Before the Board of Inquiry
Waterview Connection Project

Rebuttal evidence of **Eddie Sides (Freshwater Ecology)** on behalf of the **NZ Transport Agency**

Dated: 2 February 2011

Expert Caucusing Joint Report to the Board of Inquiry – Freshwater Ecology

Title: **STREAMWORKS & FLOOD PROTECTION OAKLEY CREEK REALIGNMENT LAYOUT PLAN**

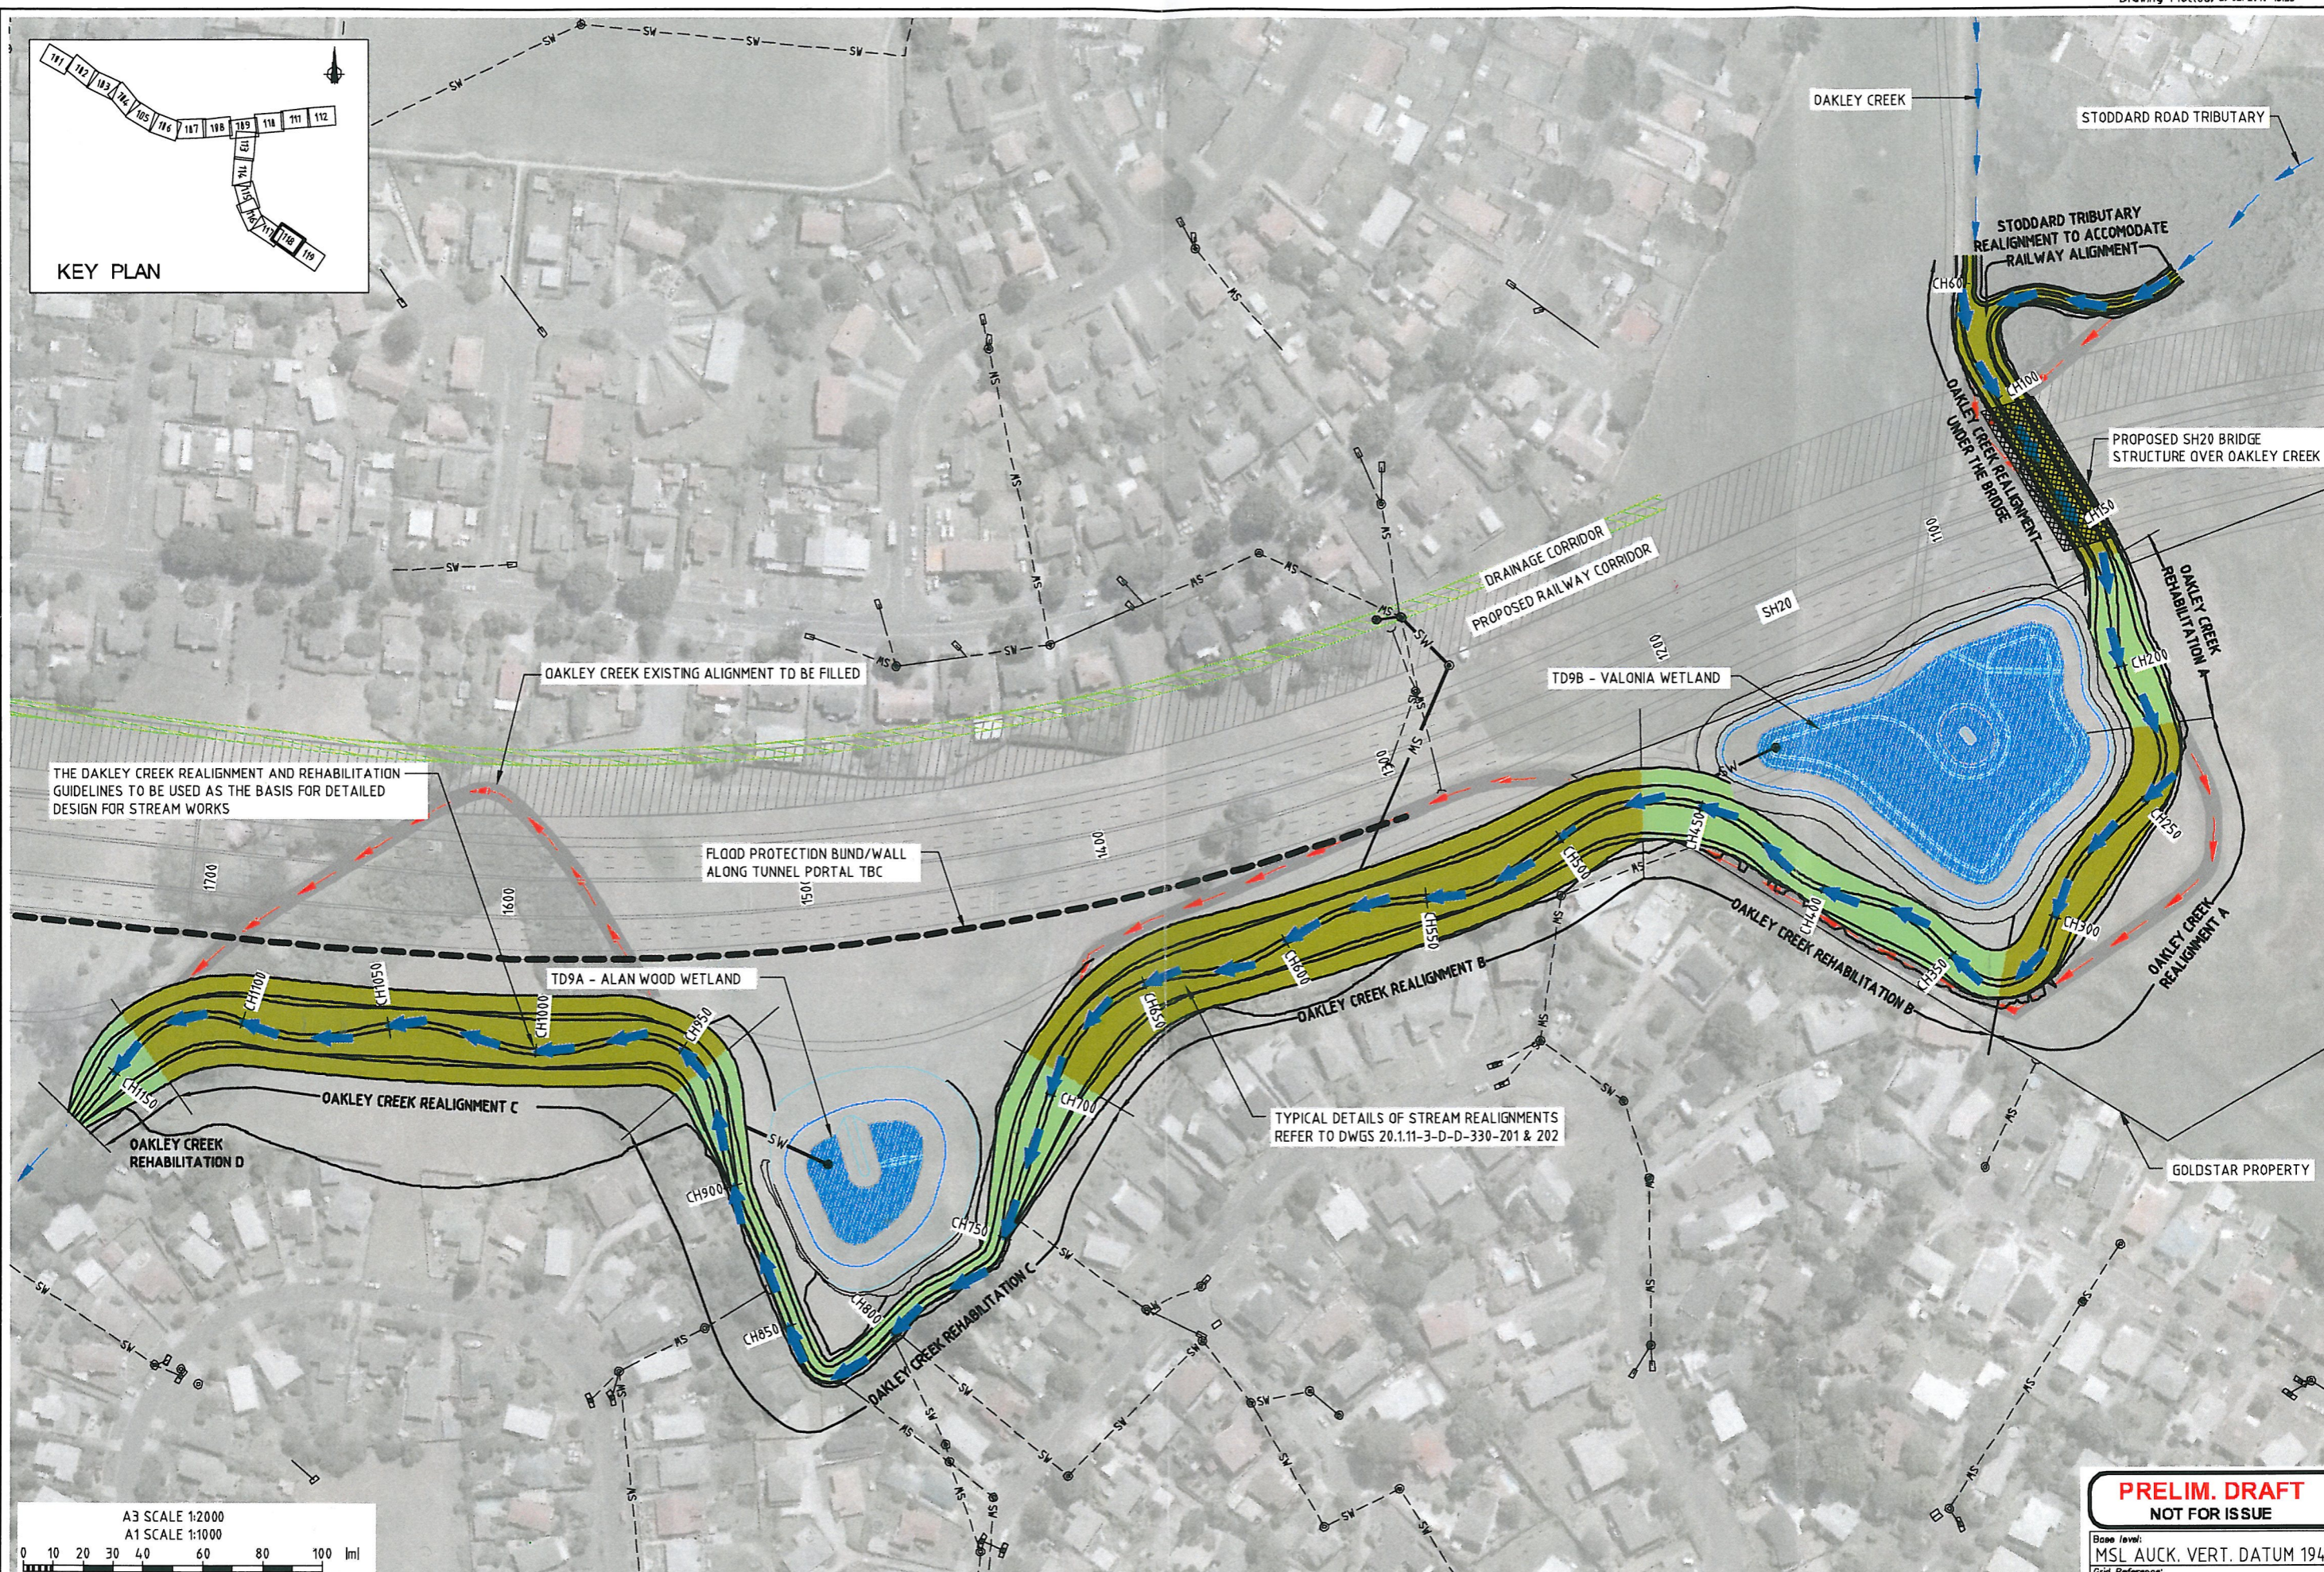
- 8.2 The realignments necessary for this Project's highway construction (coloured khaki on the Streamworks Layout Plan⁸ which is attached as **Annexure C**) measure about 870m and will be completed in accordance with the Oakley Creek Realignment and Rehabilitation Guidelines. These works are separate from any mitigation required as offset mitigation by virtue of the Stream Ecological Valuation (SEV) assessments. So, $2,750 - 870 = 1,880\text{m}$ left.

- 8.3 The other realignments (coloured light green on the Streamworks Layout plan) will also be done in accordance with the Oakley Creek Realignment and Rehabilitation Guidelines. These sections measure 448m in length. The 343m of SEV mitigation required of the Waterview Project is within this area. So, $1,880 - 343 = 1,537\text{m}$ left.

- 8.4 All other stream rehabilitation will also be completed in accordance with the Oakley Creek Realignment and Rehabilitation Guidelines. This will include the 767m of SEV mitigation required of the Maioro Interchange Project. So, $1,537 - 767 = 770\text{m}$ left.

The realignments necessary for highway construction will be rehabilitated separately to the Project's SEV off-set mitigation requirement of 343 metres. The Project's SEV off-set mitigation requirements will be undertaken within the areas demarcated as "Oakley Creek Rehabilitation A - D" as shown on Drawing 20.1.11-3-D-D-330-211 Rev A.

Advice Note : The SEV off-set mitigation associated with the Maoro Interchange Project is intended to be undertaken upstream and downstream of those areas shown for Realignment and Rehabilitation on Drawing 20.1.11-3-D-D-330-211 Rev A, for the purposes of creating a coherent ecological corridor in this area.

<u>STW20A</u>	<p><u>The realignments necessary for highway construction will be rehabilitated separately to the Project's SEV off-set mitigation requirement of 343 metres. The Project's SEV off-set mitigation requirements will be undertaken within the areas demarcated as "Oakley Creek Rehabilitation A-D" as shown on Drawing 20.1.11-3-D-D-330-211 Rev A.</u></p> <p><u>Advice Note: The SEV off-set mitigation associated with the Maoro Interchange Project is intended to be undertaken upstream and downstream of those areas shown for Realignment and Rehabilitation on Drawing 20.1.11-3-D-D-330-211 Rev A, for the purposes of creating a coherent ecological corridor in this area.</u></p>
G.12	<p>The continuous monitoring results shall be reviewed on a monthly basis to determine if there is any effect of the tunnelling on base flows in Oakley Creek. The results shall be <u>reviewed by a hydrologist and freshwater ecologist and</u> included in the 3 monthly groundwater reports, and provided to the Auckland Council.</p>
